**WHITEMARSH TOWNSHIP
SHADE TREE COMMISSION MEETING AGENDA
APRIL 7, 2026 AT 6:30 PM (IN-PERSON)**

- Grading Permit # 2026-03: Philadelphia Cricket Club; 6025 W Valley Green Road; Replacement of Existing Paver Walk & Drainage at Entry; Small Addition (Keg Enclosure)
- Grading Permit # 2026-05: Sara McMenamin; 4034 Kottler Drive; Construct Single-Family Dwelling
- Grading Permit # 2026-06: Mark Barrett; 4 Mimosa Circle; Detached Garage, Driveway Extension, & Associated Improvements

GRADING PERMIT PLANS FOR PHILADELPHIA CRICKET CLUB CLUBHOUSE IMPROVEMENTS

Date Submitted: 15 JANUARY 2026
Drawing No.
GI-001
SHEET 1 OF 8

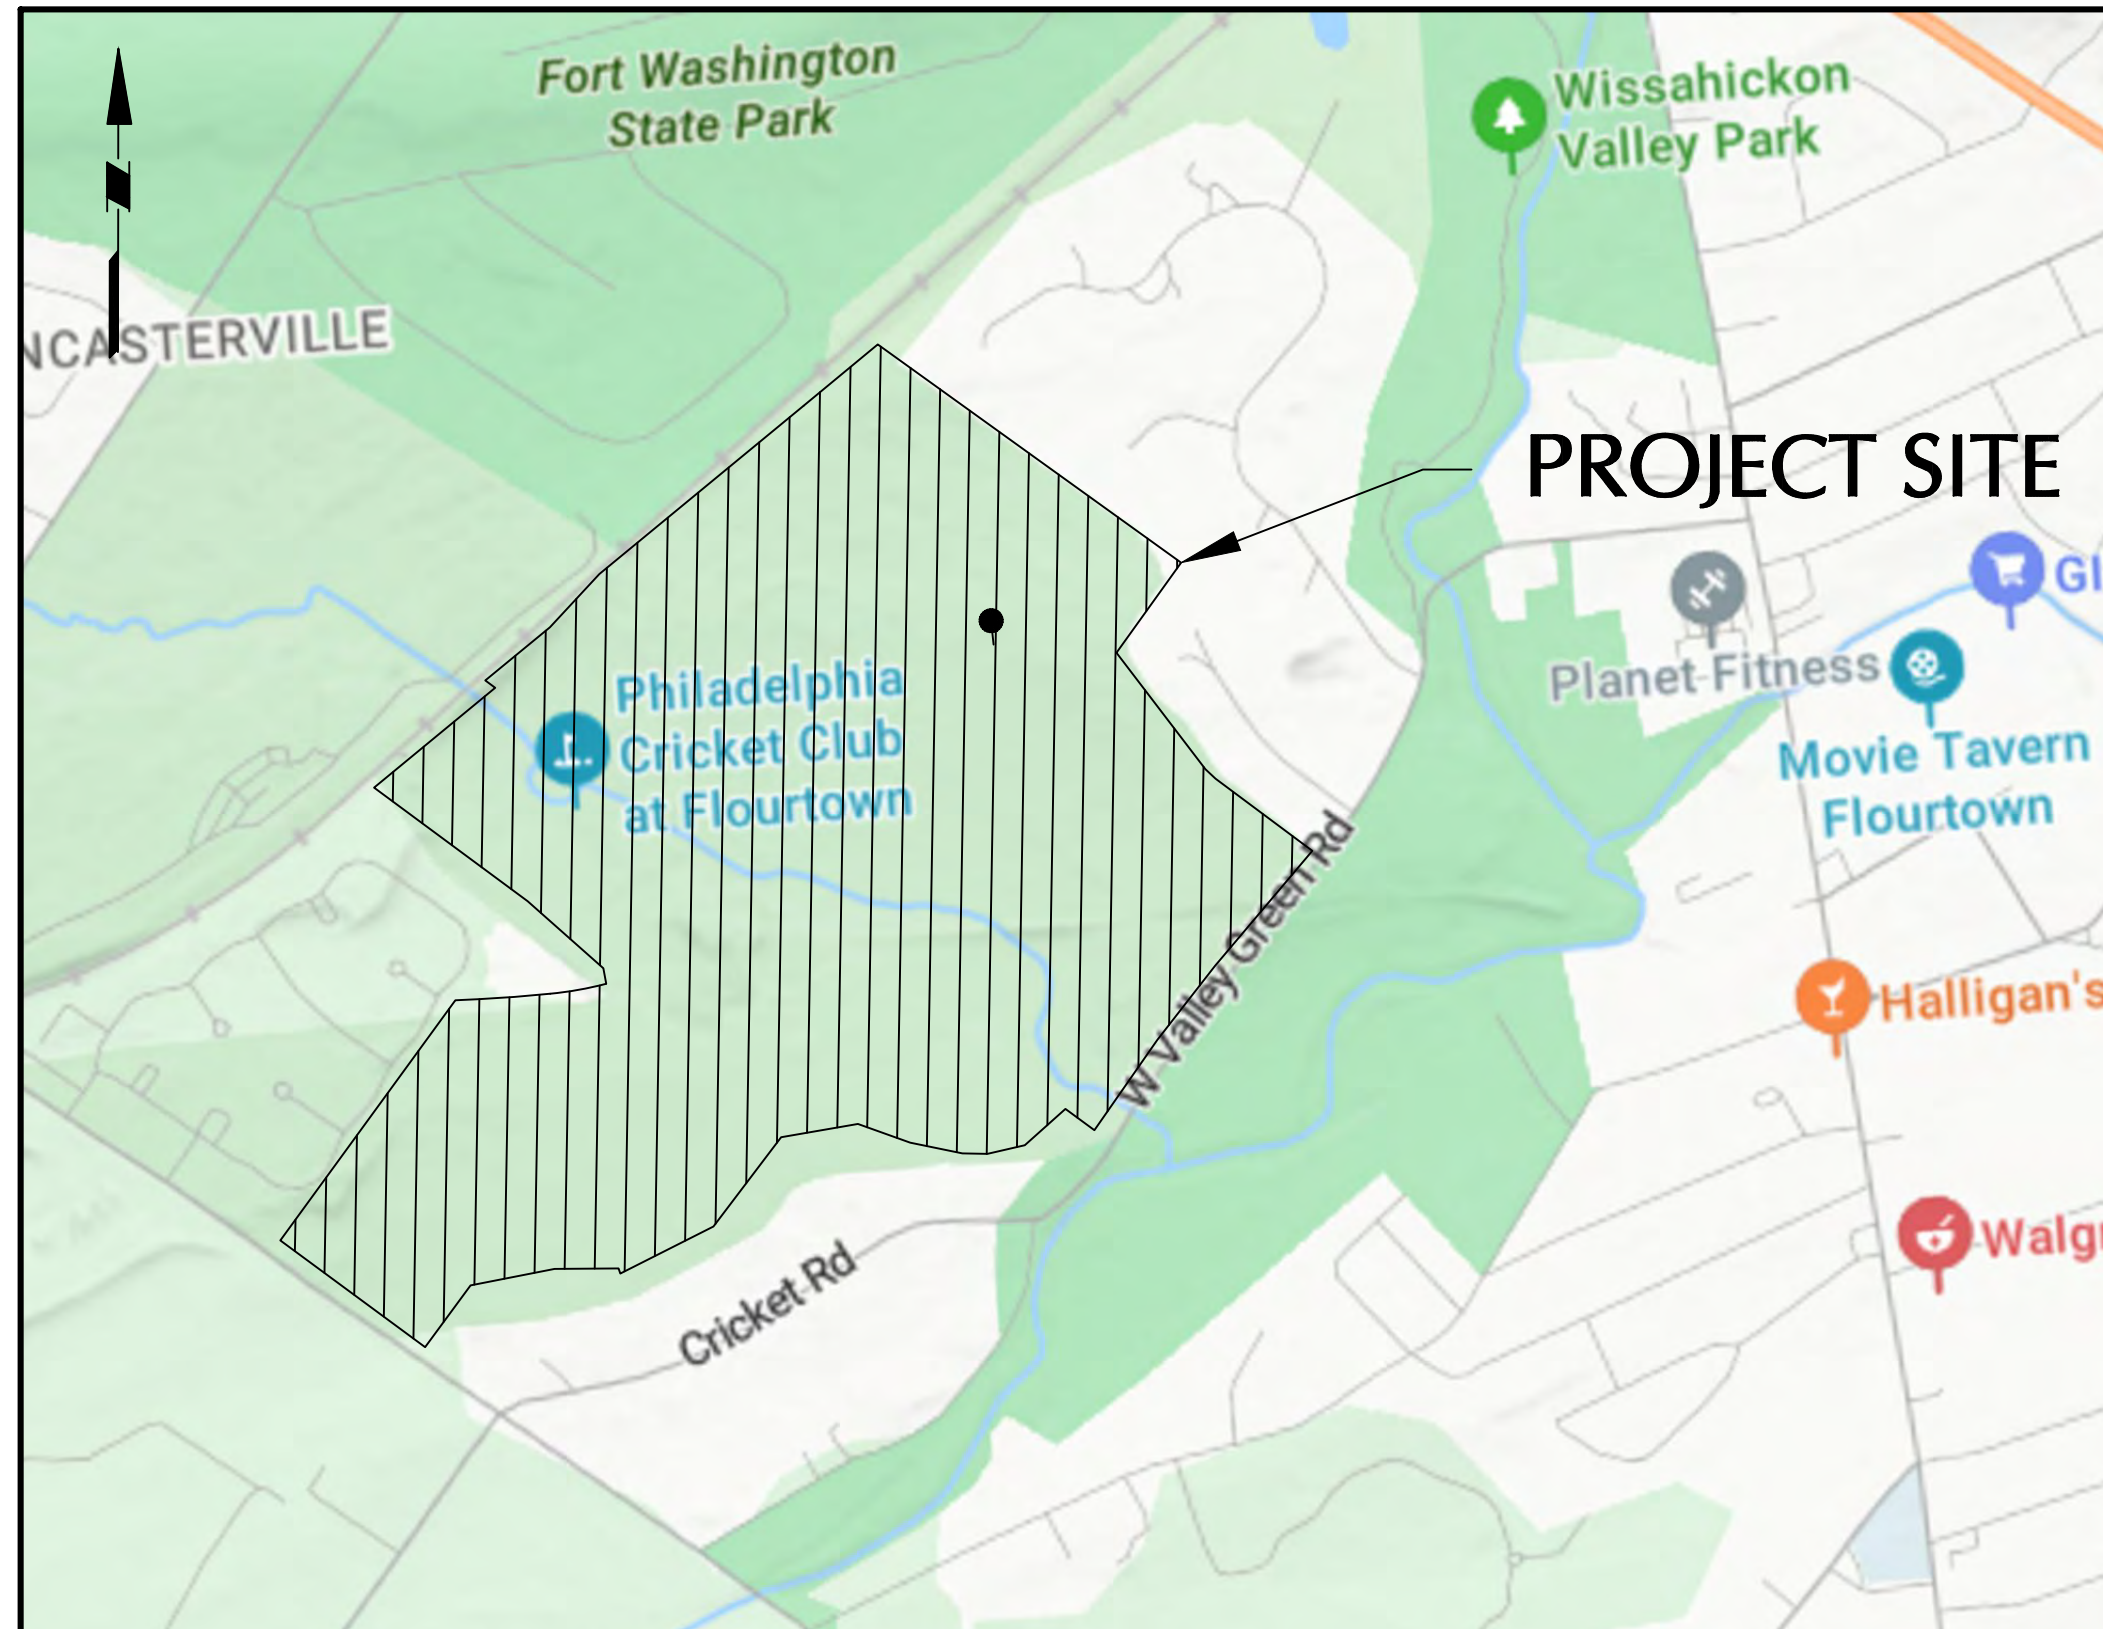
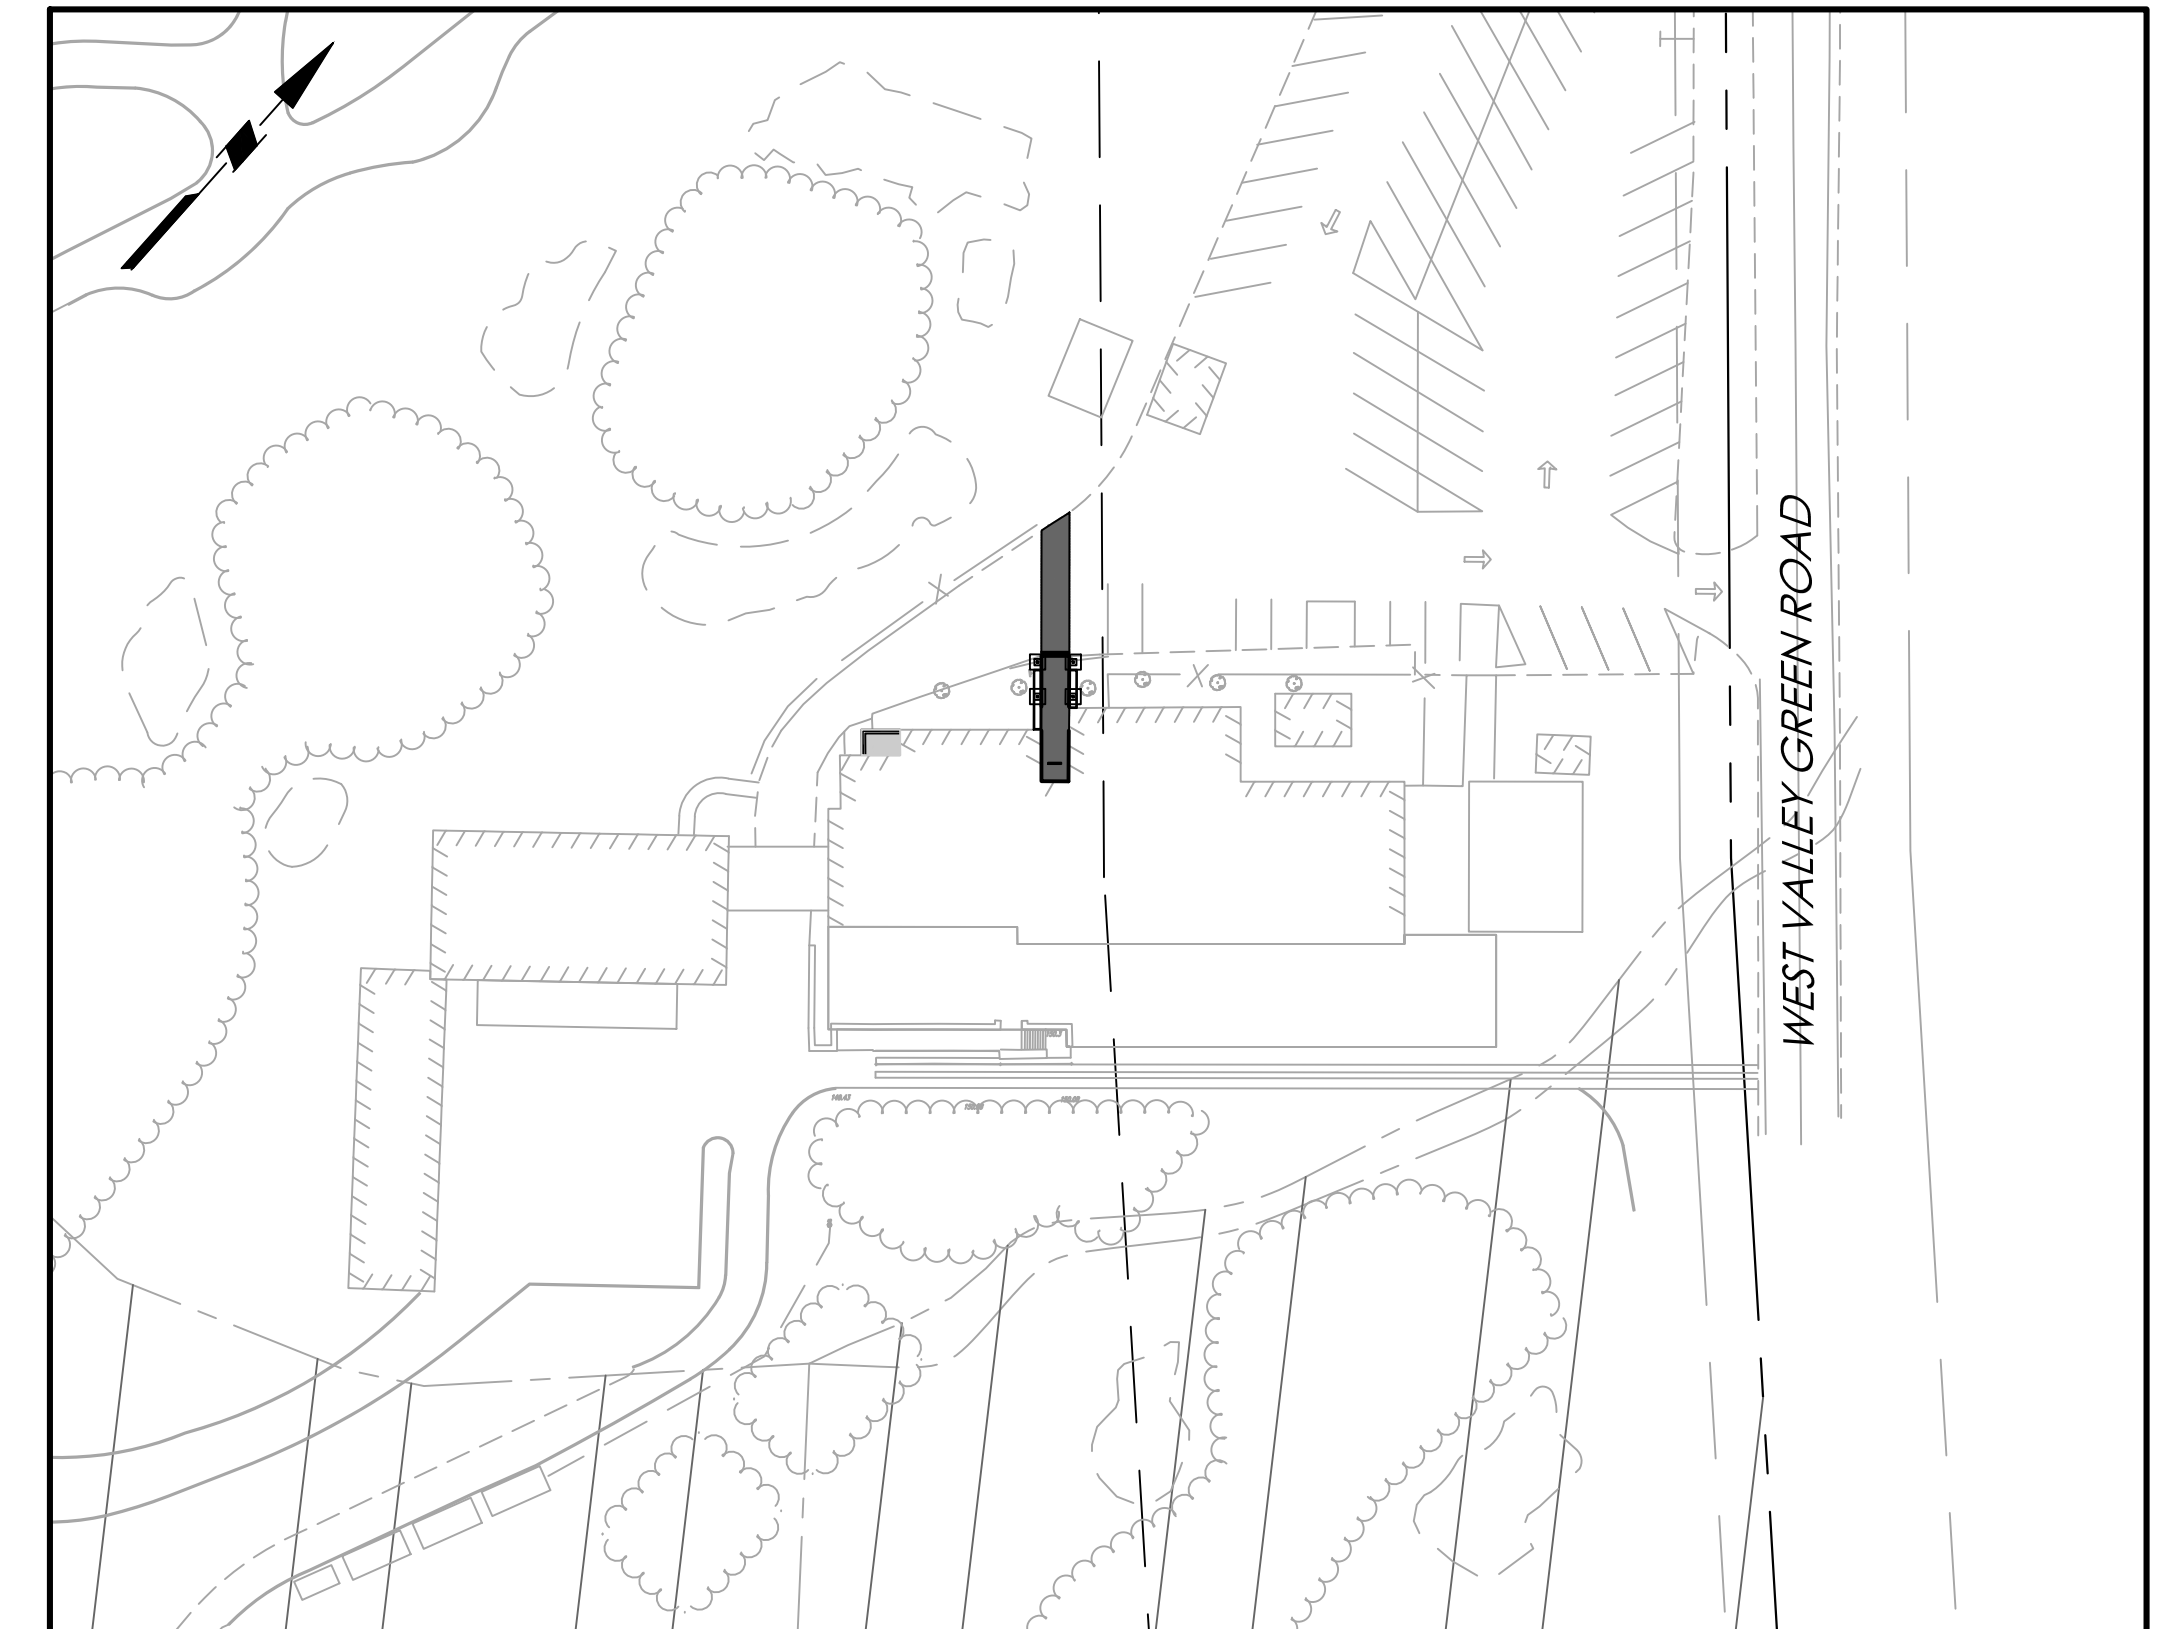
1. Section 58-17. The Drawing Index on Sheet GI-001 and individual sheet numbers should be reviewed to ensure each sheet is numbered with relationship to the total number of sheets. All sheets must be in the Drawing Index.

LANDSCAPE AND TREE PROTECTION PLAN

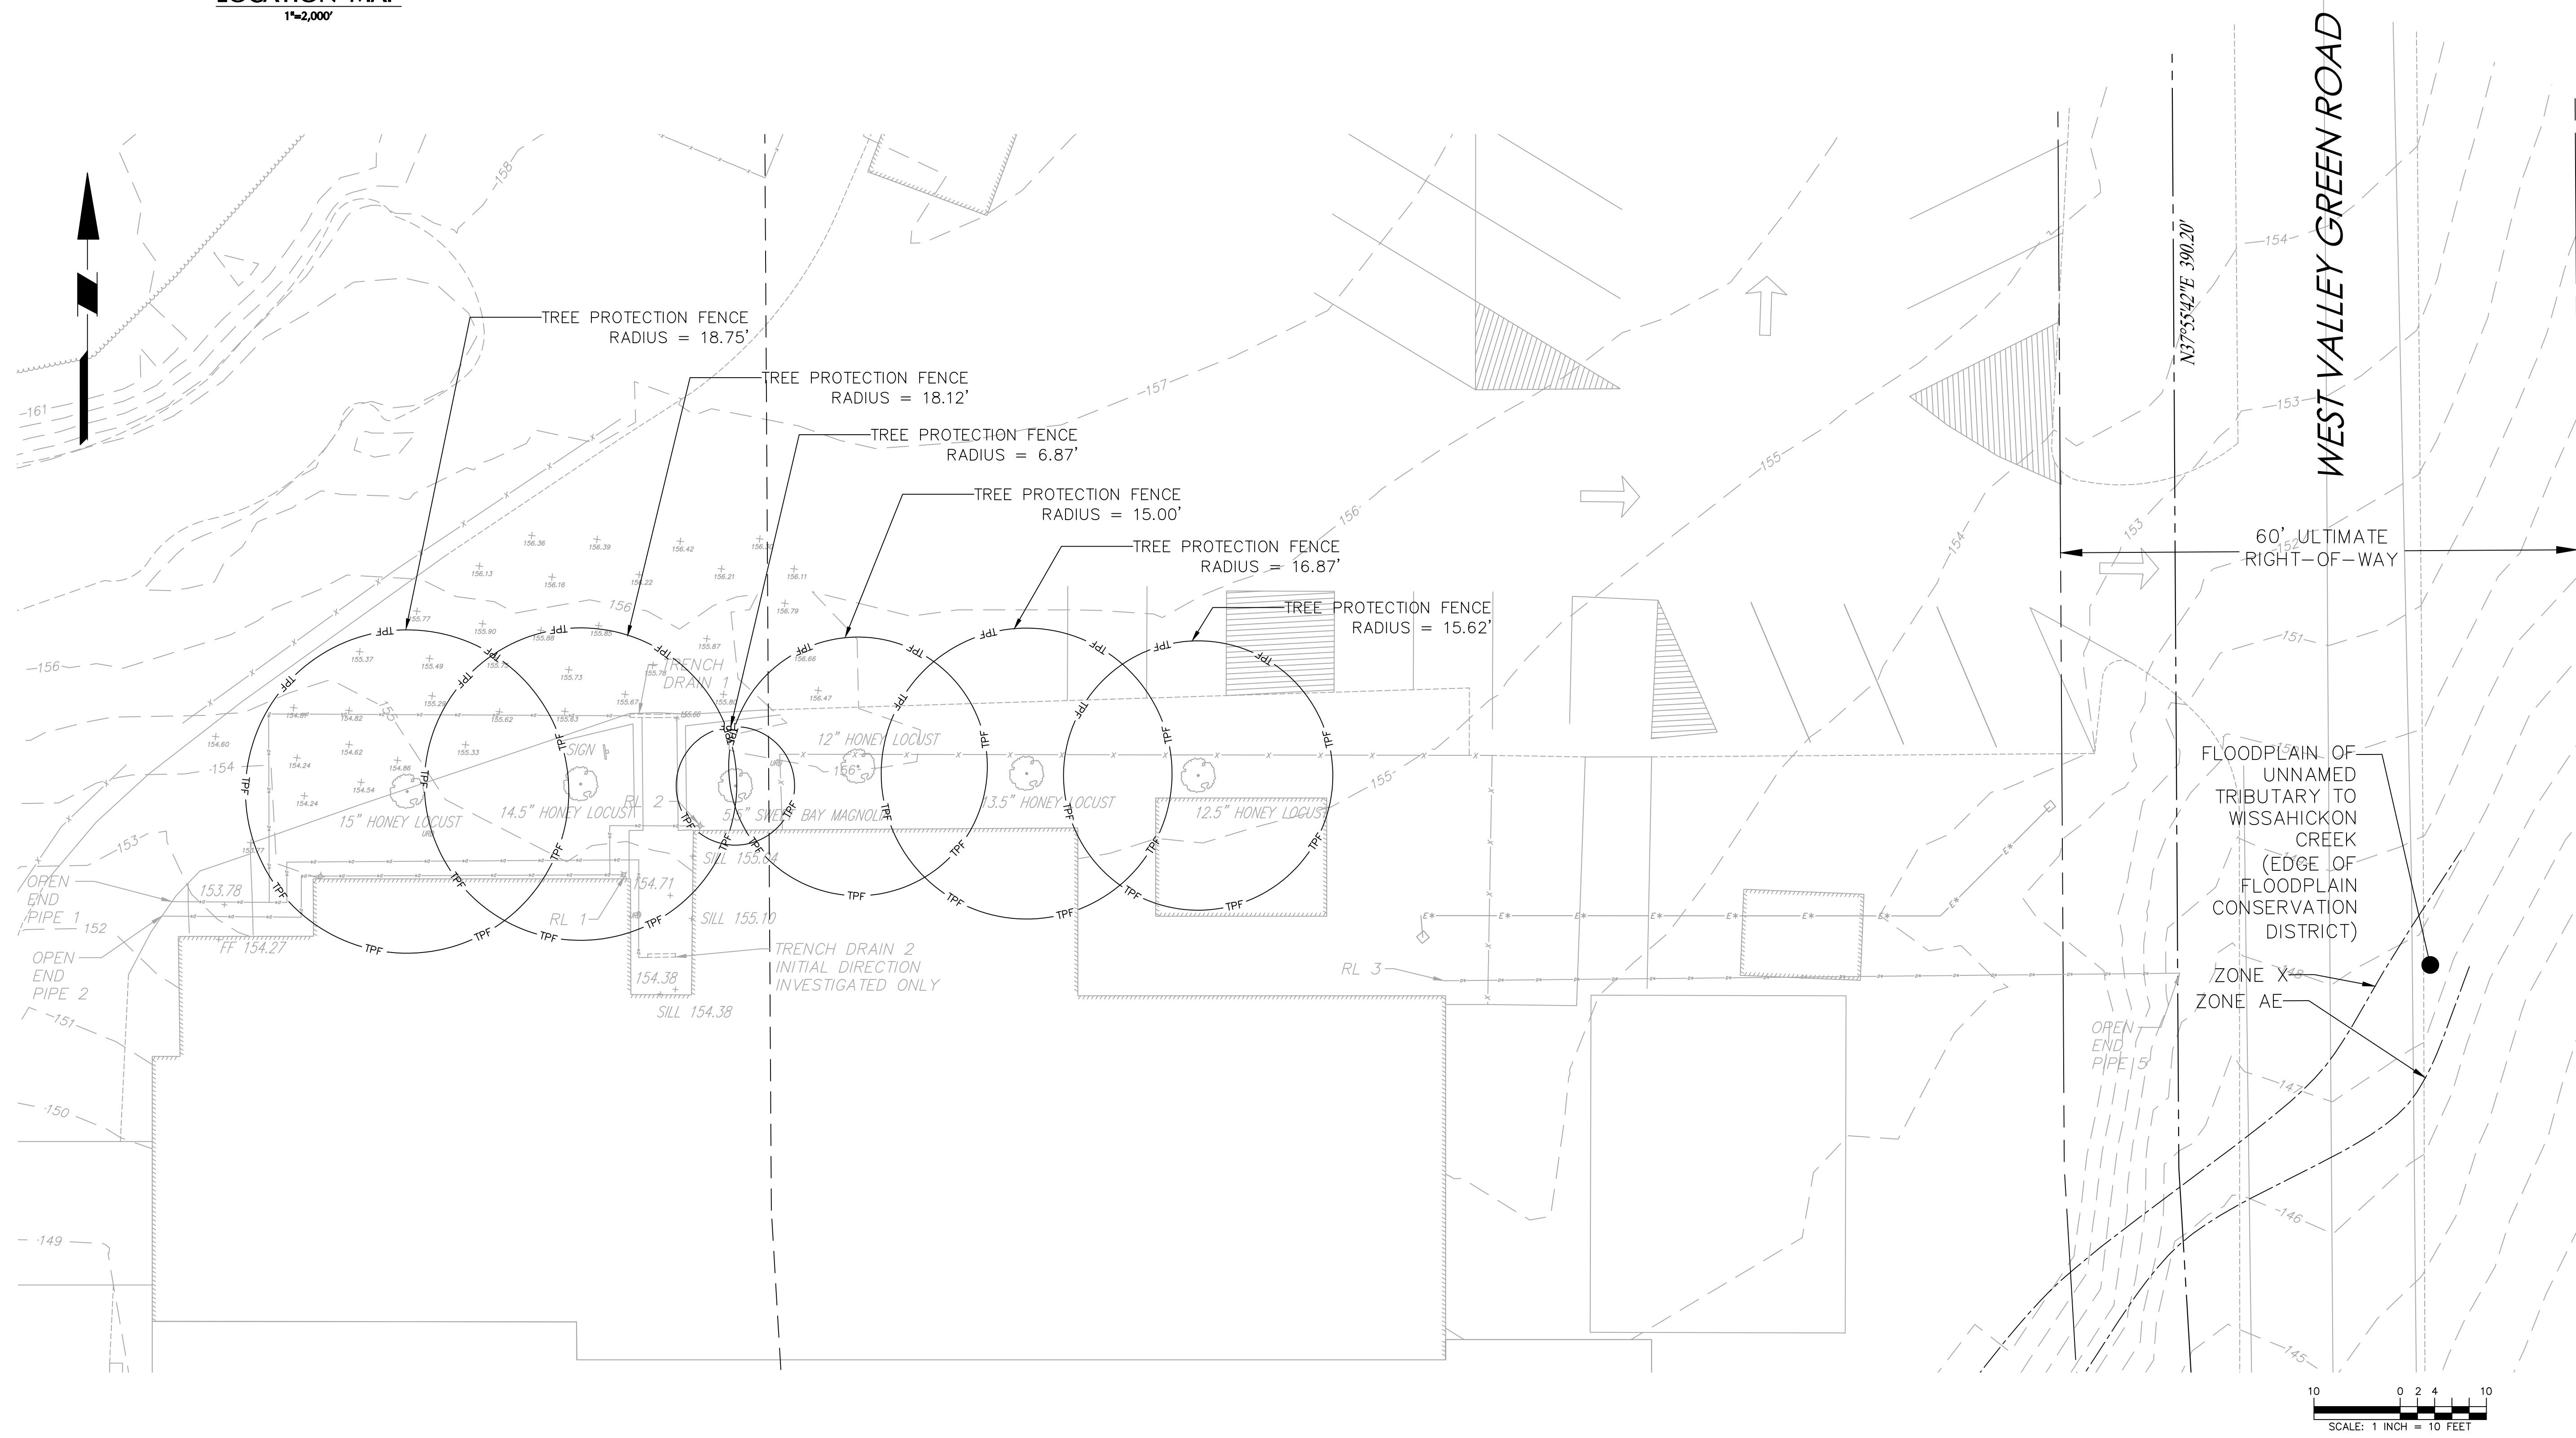
3. Section 55-4(C)(4)(b). The tree protection fencing shown on LP-101 does not appear to be consistent with those shown on Sheet CD-101. Tree Protection fencing must also be shown on Sheet CE-101. All tree protection fences must be shown encompassing the dimension of each root protection zone as established by one of the following two means, whichever is greater:
 - i. Calculated at 1.25 feet (radius) per one inch of (DBH) diameter breast height.
 - ii. A circle with a radius extending from a tree's trunk to a point no less than the furthest crown dripline.

DUE TO LIMITATIONS IMPOSED BY EXISTING SITE CONDITIONS FULL PROTECTION CANNOT BE ACHIEVED UNDER STANDARD GUIDELINES.
